**Fire Hazard Analysis
Building 929
RF Power Supply**

Brookhaven National Laboratory

Date of Last Survey: None on record
Date of Report: June 2007

Building 929 – First Floor

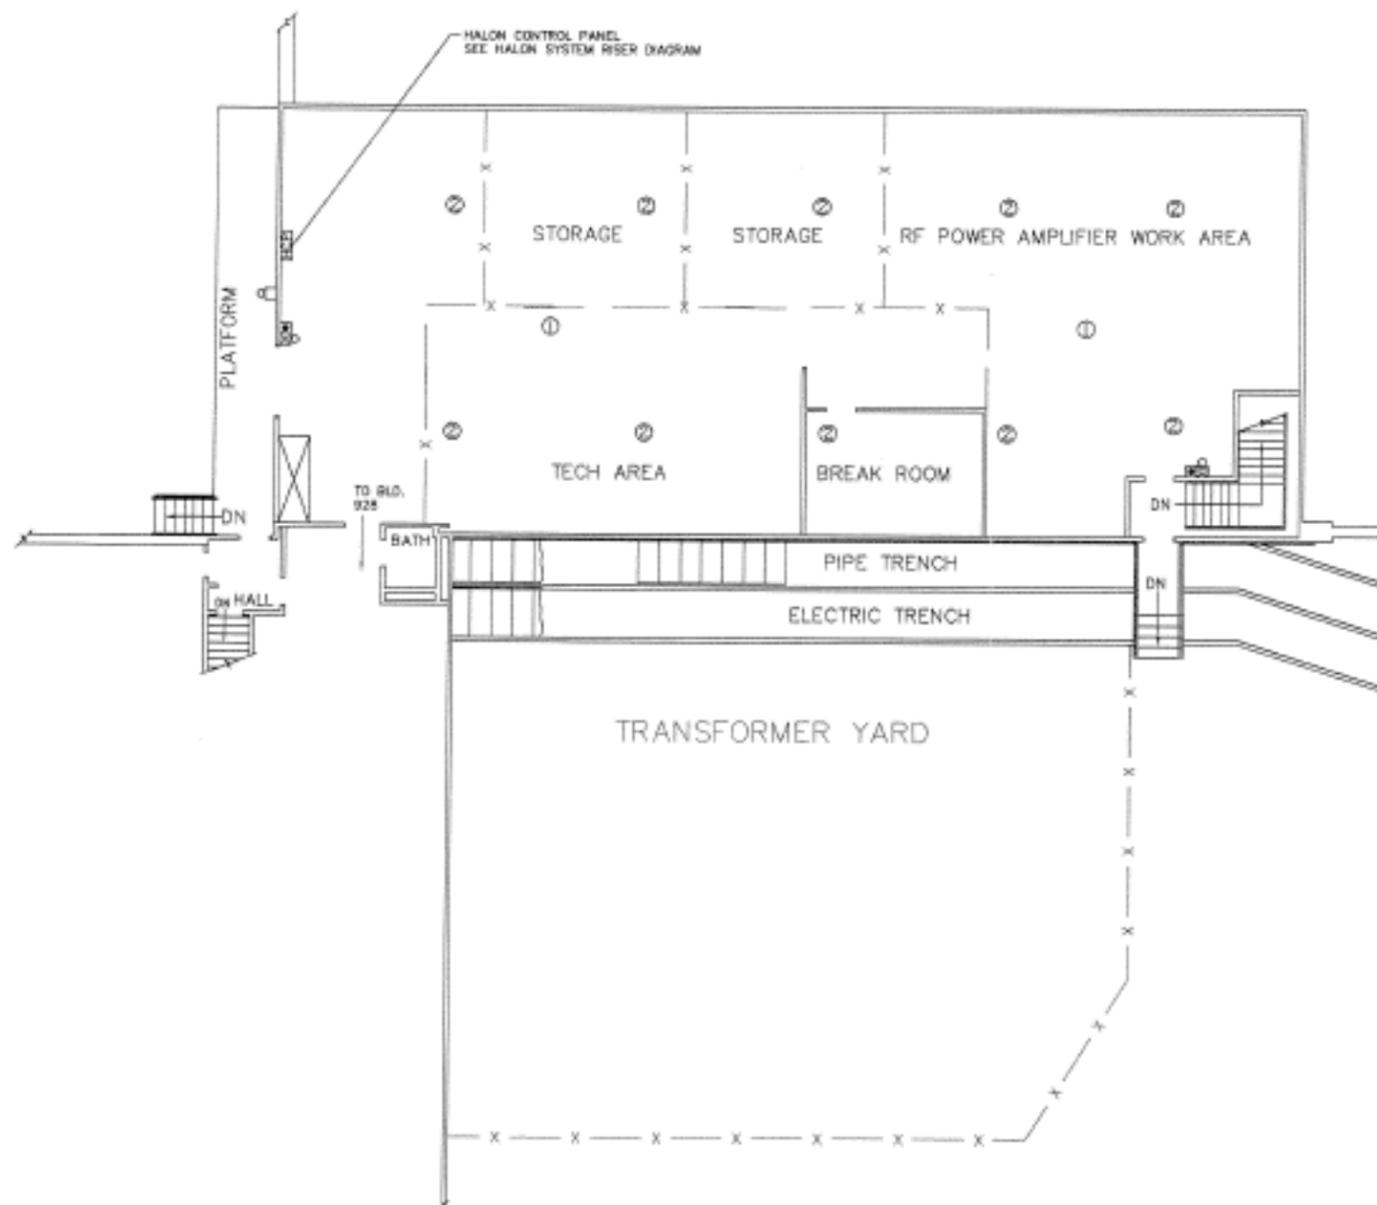
Finding: An automatic fire suppression system is not provided on the first floor including beneath the sub-floor of the building where a significant amount of wiring is present. The loss of the cabling would affect Building 928 and the AGS.

There was a Halon 1301 fire suppression system located in the first floor area of the building, but it has been removed from service since the RF equipment is no longer utilized. However, there is critical cabling that runs through the building that is vital to Building 928 that should be protected (See Recommendation **HAI-07-929-01**).

Recommendation HAI-07-929-01: An automatic fire suppression system, either automatic sprinklers or a gaseous system should be provided for the first floor area of Building 929, including the sub-floor area where critical cabling is located. (See Section 5.1.5)
